Technical Service Bulletin: TSB180043

New Lubricating Oil Filter Head and Lubricating Oil Cooler Cover Gasket

Figure 1: Left: Lubricating Oil Filter Head. Right: Existing Lubricating Oil Filter Head.

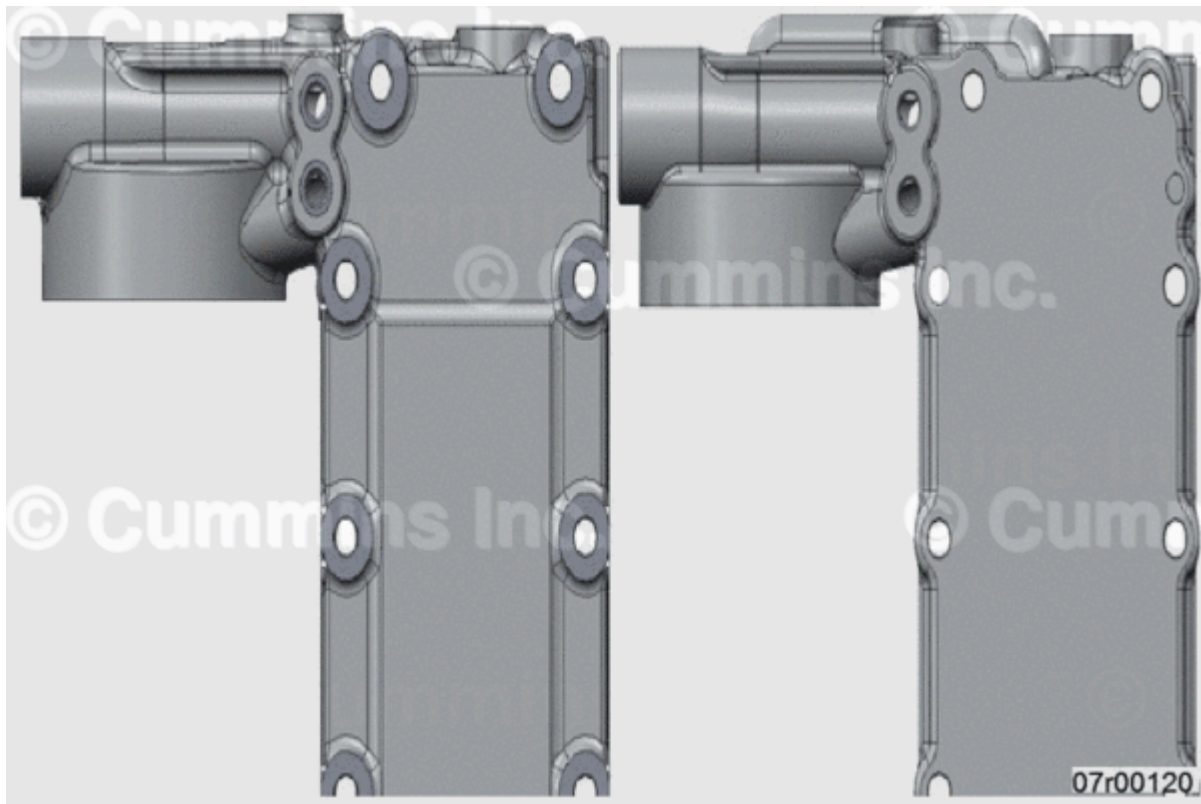
- A new lubricating oil filter head and lubricating oil cooler cover gasket are available.
- Lubricating oil filter head increases sealing flange and front wall thickness.
- Lubricating oil cooler cover gasket coating material was changed and embossments were added around sealing perimeter.

- Lubricating oil filter head was improved to reduce lubricating oil filter head cracking and external lubricating oil leaks.
- Lubricating oil cooler cover gasket was improved to reduce external lubricating oil leaks.

- New lubricating oil filter head can be identified by added capscrew machined bosses (see Figure 1).
- New lubricating oil cooler cover gasket can be identified by embossments around sealing perimeter (see Figure 2).

- If existing lubricating oil filter head has malfunctioned, replace with new lubricating oil filter head.

- New lubricating oil cooler cover gasket **must** be used with new lubricating oil filter head.
- If existing lubricating oil cooler cover gasket has malfunctioned, replace with existing part number.

New lubricating oil cooler cover gasket is **only** compatible with new lubricating oil filter head part numbers.
